LABORATORY MIXING FAUCET, DECK MOUNTED, 6" RIGID/SWING VACUUM BREAKER GOOSENECK, CERAMIC DISC UNITS, WRIST BLADE HANDLES

SUBMITTAL IDENTIFICATION SHEET

WEBSTER UNIVERSITY ISB	
PROJECT NAME	
8274 BIG BEND BLVD	
ADDRESS	
NUMBER	
WEBSTER UNIVERSITY	
OWNER	
CANNON DESIGN	
ARCHITECT / ENGINEER	
DEVIN D GATES	
SUBMITTED BY	
123553-001 REV 2	
CONTRACTOR / CM SUBMITTAL NO.	CANNON DESIGN SUBMITTAL NO.
	123553
DRAWING / DETAIL REFERENCE	SPECIFICATION SECTION / PARAGRAPH
MANUFACTURER / SUPPLIER	ITEM / PRODUCT ID
REQUIRED DATE	PRIORITY
	CRITICAL

CTC414VB-BH-WHT

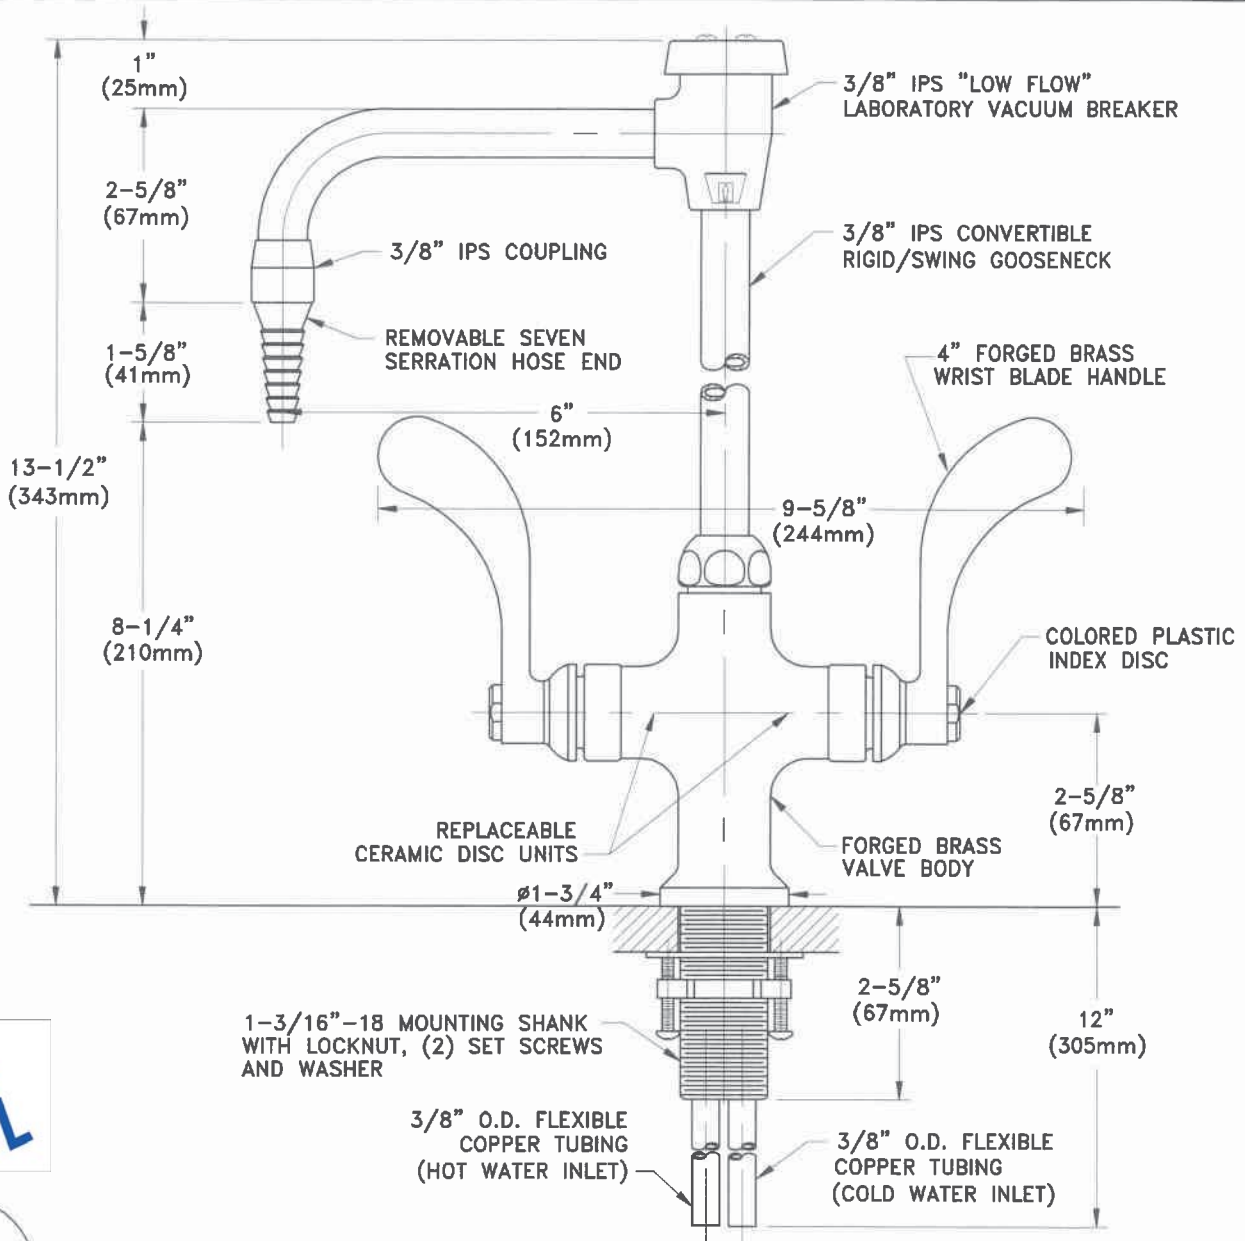
-EW, DH & PRE-RINSE FIXTURE APPROVAL ON HOLD.
